DeSPACE (International) Limited

**Lots 3719 S.G ss.9 RP, 3719 S.G ss.10 (Part) in D.D.104
and Adjoining Government Land, Nam Sang Wai, Yuen Long
Section 16 Planning Application No. A/YL-NSW/372
Further Information (3)**

References are made to the email dated 14th July 2026 in relation to the comments from TD. In order to address the comments, please find the response-to-comment table below, **Attachment 1** for the replacement pages of the Planning Statement, and **Attachment 2** for the replacement pages of Drawings/Figures.

DRAWING TITLE: PRIVATE VEHICLE SWEEP PATH PLAN	LEGEND: APPLICATION BOUNDARY PRIVATE CAR PARKING SPACE (5m x 2.5m) ENCLOSED STRUCTURE LIGHT GOODS VEHICLE LOADING/UNLOADING BAY (7m x 3.5m)	SCALE: 1:250	PREPARED BY:  DeSPACE (International) Limited
DRAWING NO.: FIGURE 3a		DATE: JULY 2026

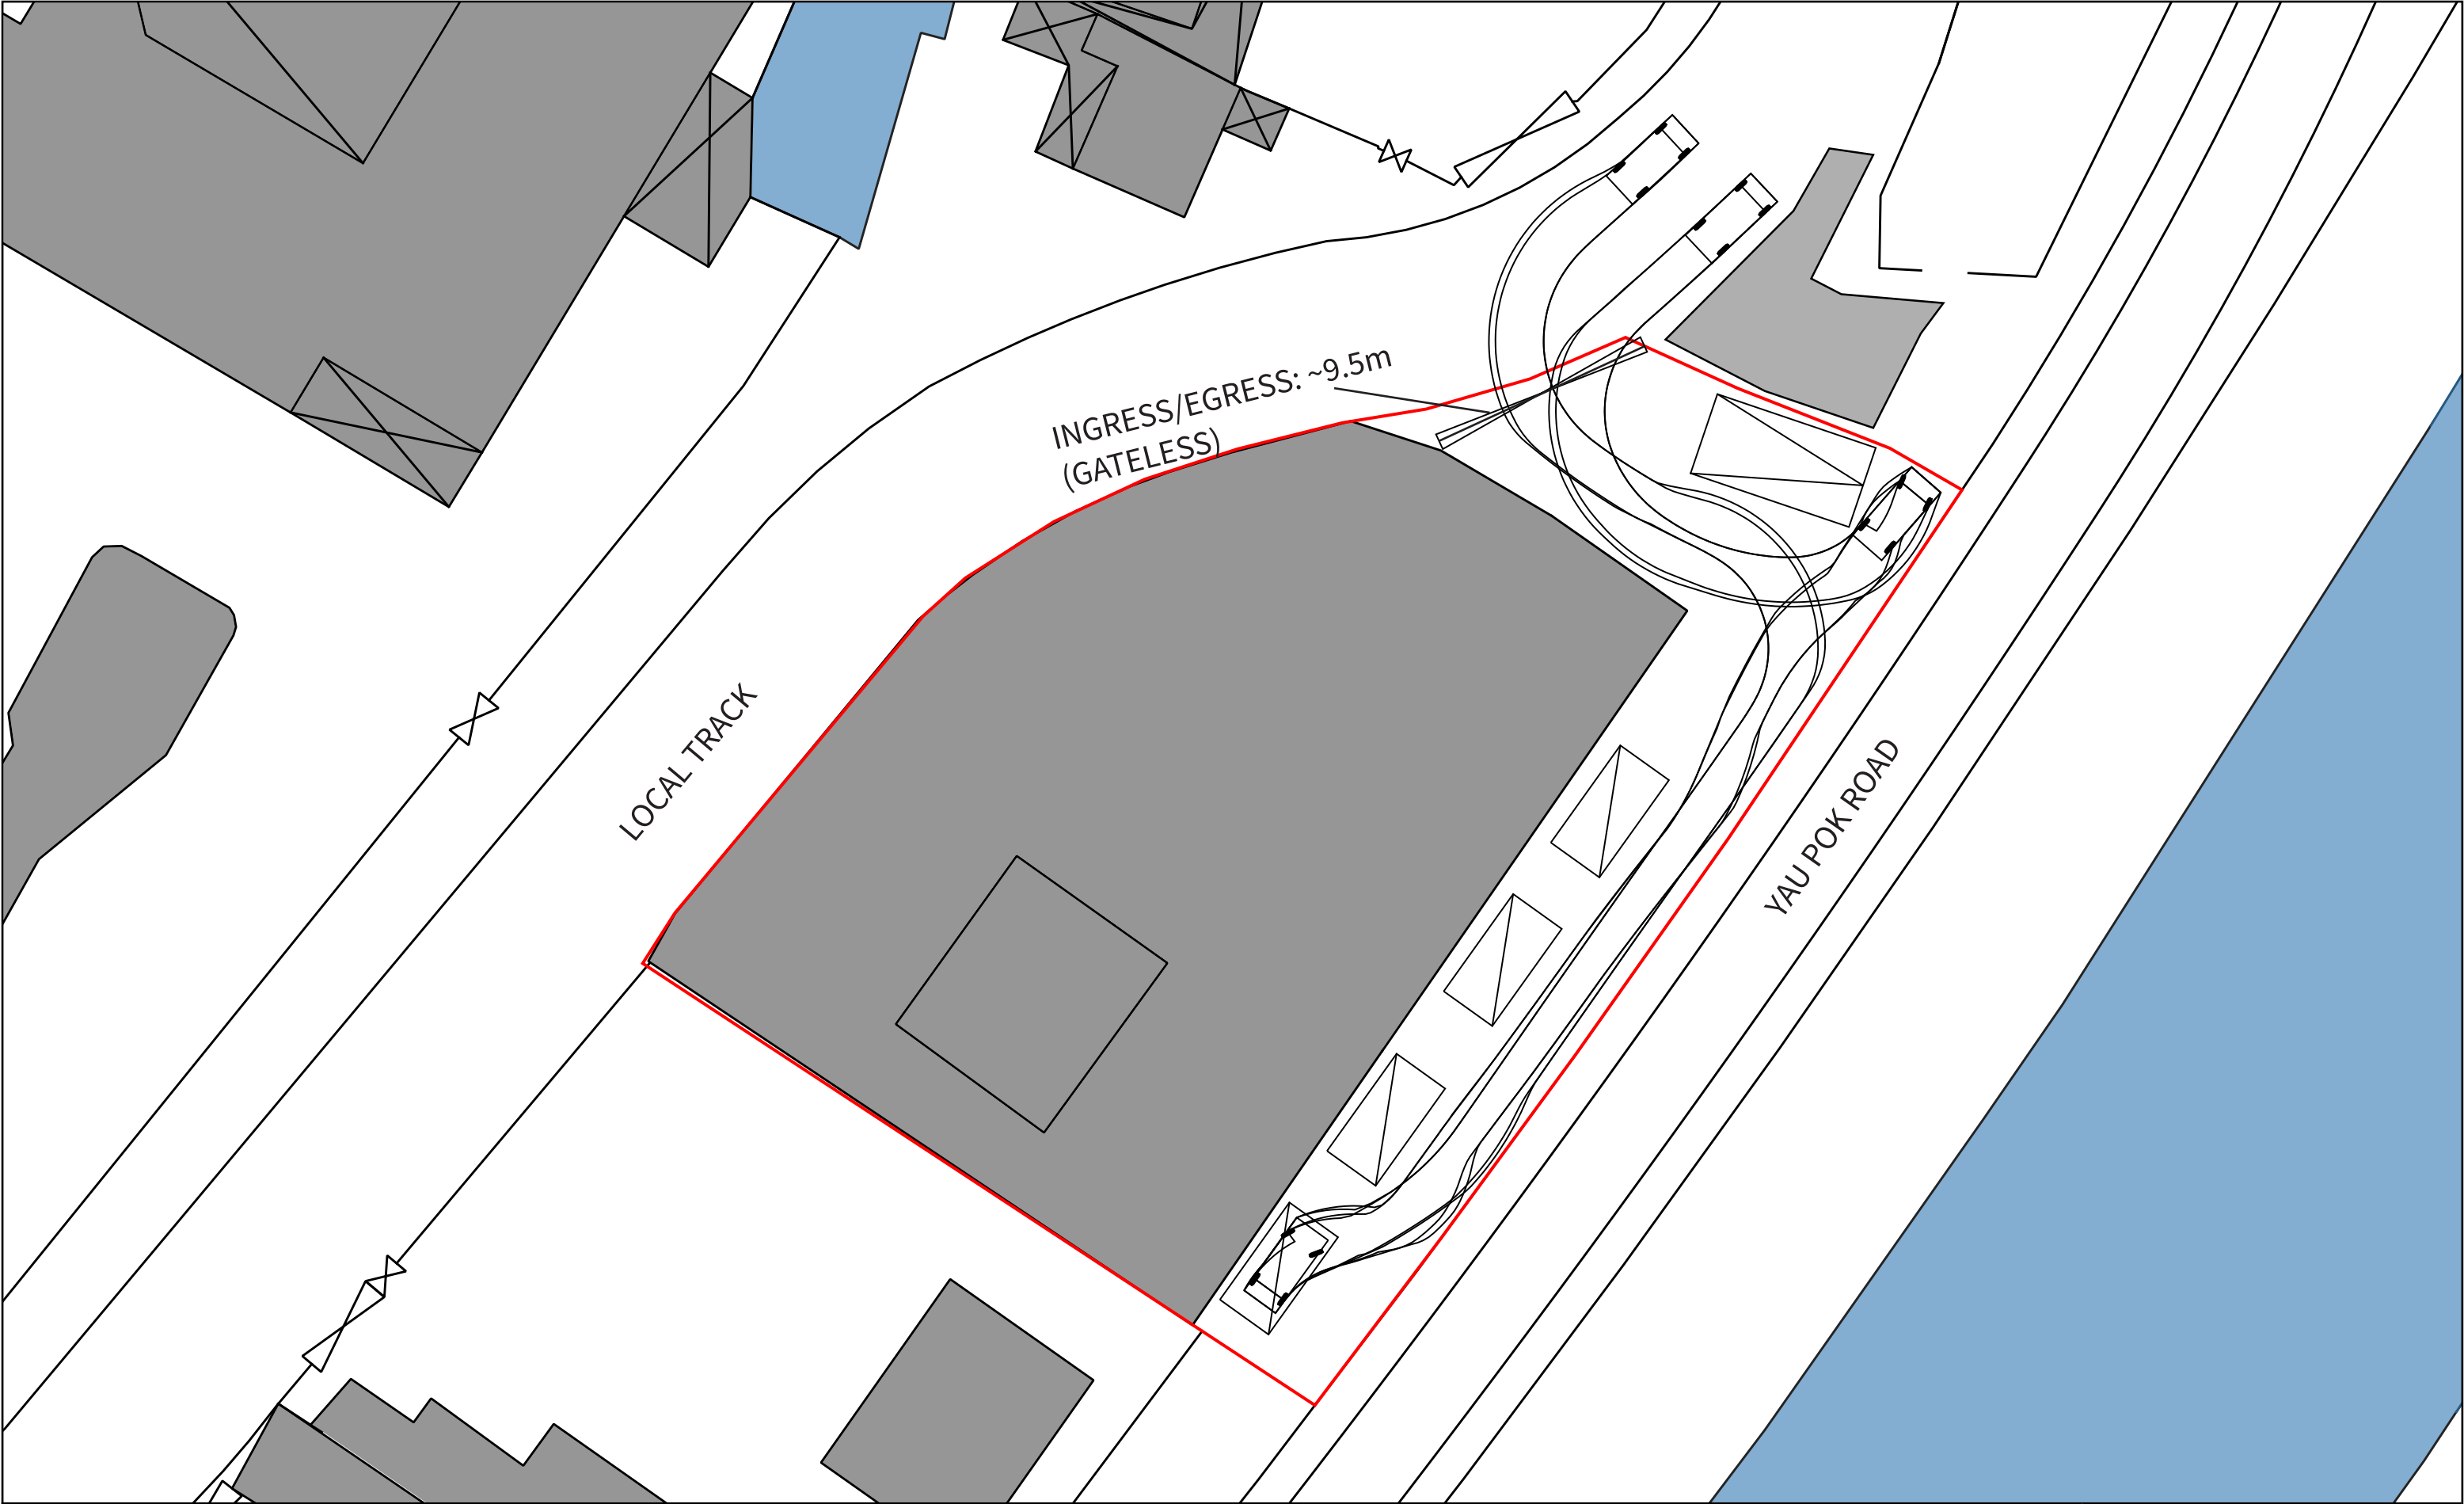
Dimension of the proposed car parking space and L/UL space shall follow HKPSG. Please provide a plan showing to-to-scale parking space and L/UL space.	Figures 3a and 3b in Attachment 2 are updated to demonstrate the dimensions of said spaces.
Swept path analysis should be conducted based on a to-scale drawing. Please update.	Figures 3a and 3b are replaced with 1:250 scale.
Please advise the width of site entrance and indicate it clearly on plan.	The width of the site entrance is supplemented in Figures 3a and 3b.
